dsPIC33EVXXXGM00X/10X Family Silicon Errata and Data Sheet Clarification

The dsPIC33EVXXXGM00X/10X family devices that you have received conform functionally to the current Device Data Sheet (DS70005144H), except for the anomalies described in this document.

FIGURE 1:

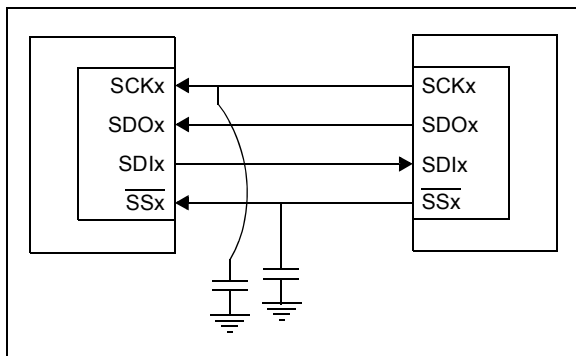
When the SPIx module is configured in SPIx Slave mode (MSTEN bit (SPIxCON1[5]) = 0), the frame slave (FRMEN bit (SPIxCON2[15]) = 1) and the SPIFSD bit (SPIxCON2[14] = 1), in Standard Buffer mode with the Clock Polarity Select bit, CKP = 0, the data are not transmitted in both 8-bit and 16-bit mode, but the data are being received correctly.

Adding a capacitance on the signal, as shown in Figure 1, will help the data to be received properly.

FIGURE 2: TIMING DIAGRAMS FOR CENTER-ALIGNED AND EDGE-ALIGNED MODES

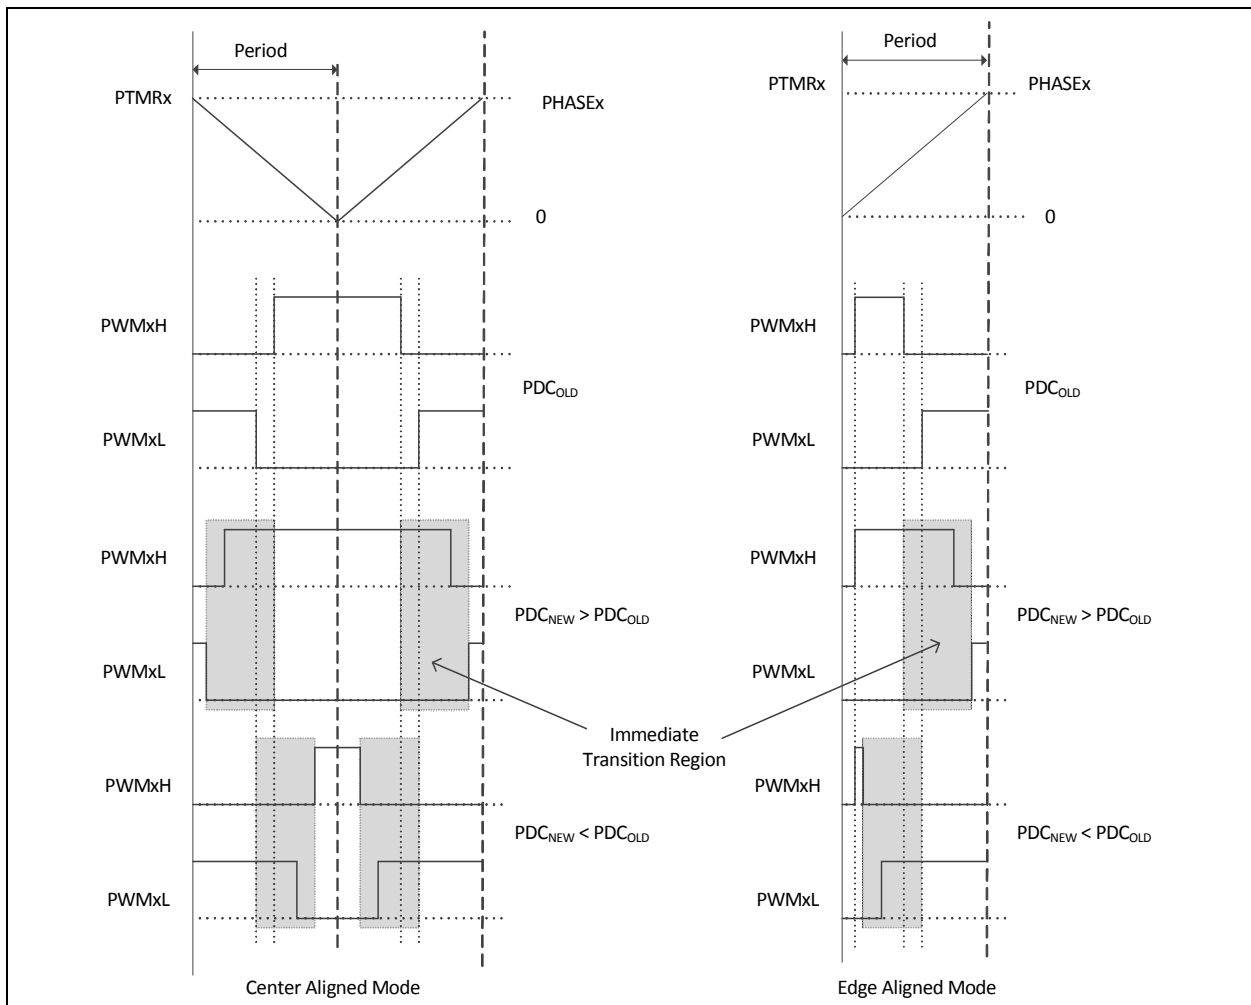
The PWM generator may not assert dead time on the edges of transitions. This has been observed when all of the following conditions are present:

In [Figure 2](#), if the duty cycle write occurred in the shaded box, then PWMxH and PWMxL will make an immediate transition without dead time.

However, in most applications, the duty cycle update timing can be controlled using the TRIGx trigger or Special Event Trigger, such that the above mentioned conditions are avoided altogether.

FIGURE 3: ILLUSTRATION OF 1 T_{osc} GLITCH WHEN PWM OVERRIDE IS TURNED OFF

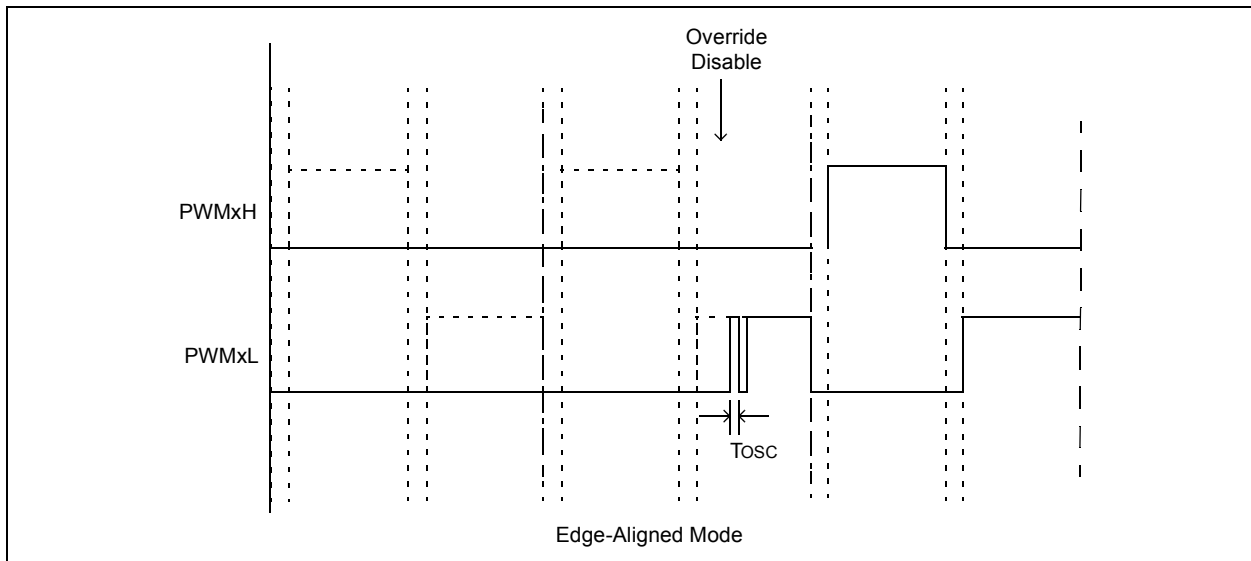
In Complementary mode after the PWM module is enabled (PTEN = 1), if the PWM override is turned off, a one T_{osc} glitch will be present on the rising edge of either the PWMxH or PWMxL pins, whichever occurs first, as shown in Figure 3.

The glitch will be present on PWMxH/PWMxL every time the override state is changed from override enabled to override disabled. The width of this glitch is equal to one T_{osc} when PCLKDIV[2:0] (PTCON2[2:0]) = 000. Increasing the PWMx input clock prescaler setting will increase the width of the glitch accordingly.

FIGURE 4:

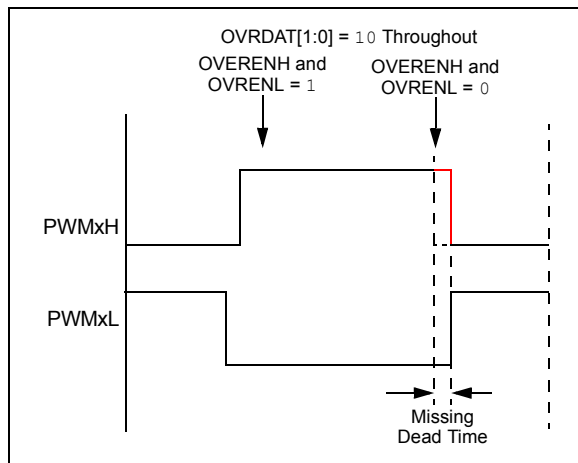
In Complementary Output mode, the expected dead time between transitions of the PWMxH and PWMxL outputs may not be asserted when the following occurs:

- Output override synchronization is configured to occur on the CPU clock boundary (IOCONx[0] = 0);
- Both PWMxH and PWMxL overrides are enabled prior to the event (OVRENH and OVRENL are both '1'), and
- Both overrides are disabled (OVRENH and OVRENL are both '0') at the instant the dead time should be asserted (Figure 4). This has been observed in both Center-Aligned and Edge-Aligned modes.

FIGURE 5:

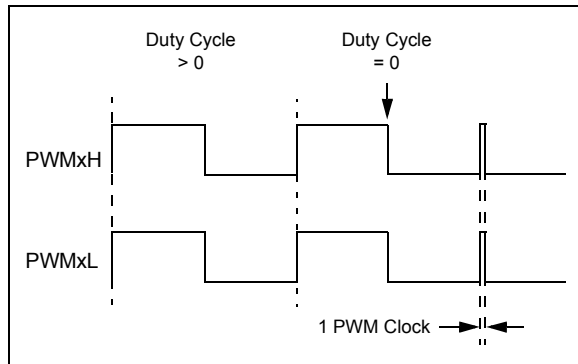
In the Redundant Output mode (IOCONx[11:10] = 10) and Push-Pull Output mode (IOCONx[11:10] = 01) with Immediate Update disabled (PWMCONx[0] = 0), when the Duty Cycle register is updated from a non-zero value to zero, a glitch pulse of a width equal to one PWM clock will appear at the next PWM period boundary, as shown in Figure 5, for the Redundant Output mode. Here, the Duty Cycle register refers to the PDCx register if PWMCONx[8] = 0 or the MDC register if PWMCONx[8] = 1.

1. Use the PWM override feature to override the PWM output to a low state instead of writing to the Duty Cycle register. In order to switch back to a non-zero duty cycle output, turn off the PWM override. The override-on and override-off events must be timed close to the PWM period boundary if the IOCONx register has been configured with IOCON[0] = 0 (i.e., output overrides via the OVDDAT[1:0] bits occur on the next CPU clock boundary).

2. Enable the Immediate Update (PWMCONx[0] = 1) while configuring the PWM module, i.e., before enabling the PWM module (PTCON[15] = 1). With Immediate Update enabled, writes to the Duty Cycle register can have an immediate effect on the PWM output. Hence, duty cycle write operations must be timed close to the PWM period boundary in order to avoid distortions in the PWM output.

FIGURE 6:

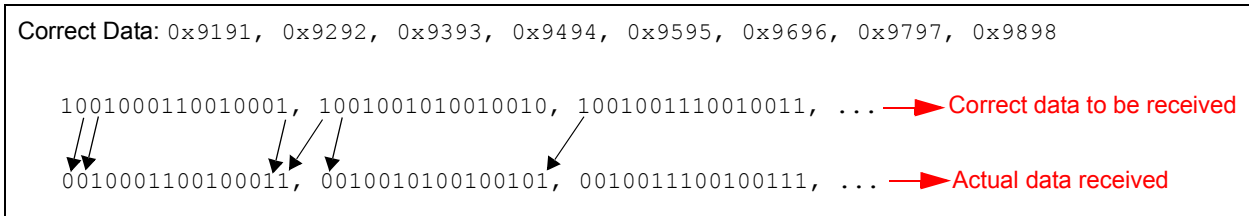
Received data of the SPI are sampled one clock cycle late for the following conditions:

For example, the correct data that should be received are 0x9191, 0x9292, 0x9393, 0x9494, 0x9595, 0x9696, 0x9797, 0x9898, but the actual data received are 0x2323, 0x2525, 0x2727, 0x2929, 0x2B2B, 0x2D2D, 0x2F2F, 0x3130 (Figure 6).

FIGURE 7: SIMPLIFIED BEHAVIOR

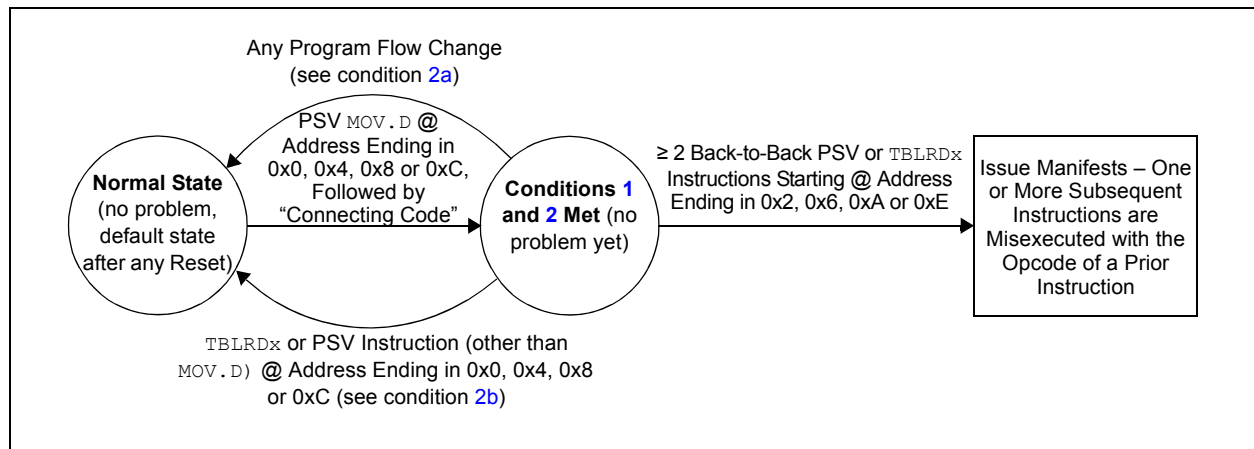
3.	≥ 2 back-to-back PSV or <code>TBLRDx</code> instructions are executed (following the code of condition 2), where the first of the back-to-back instructions is located at an address ending in 0x2, 0x6, 0xA or 0xE.

[Figure 7](#) provides an example of the effective behavior.

1. All instances of PSV `MOV.D` can be replaced with two PSV `MOV` instructions instead. Non-PSV `MOV.D` instructions acting on RAM/SFRs do not need to be modified; or
2. If not already present, a program flow change instruction (such as `BRA $+2`) can be inserted above back-to-back data Flash read sequences; or
3. Back-to-back data Flash read instruction sequences can be broken up by inserting a non-Flash read instruction (such as a `NOP`), in between the Flash read instructions; or
4. The alignment of the code can be shifted to avoid the required opcode location addresses.
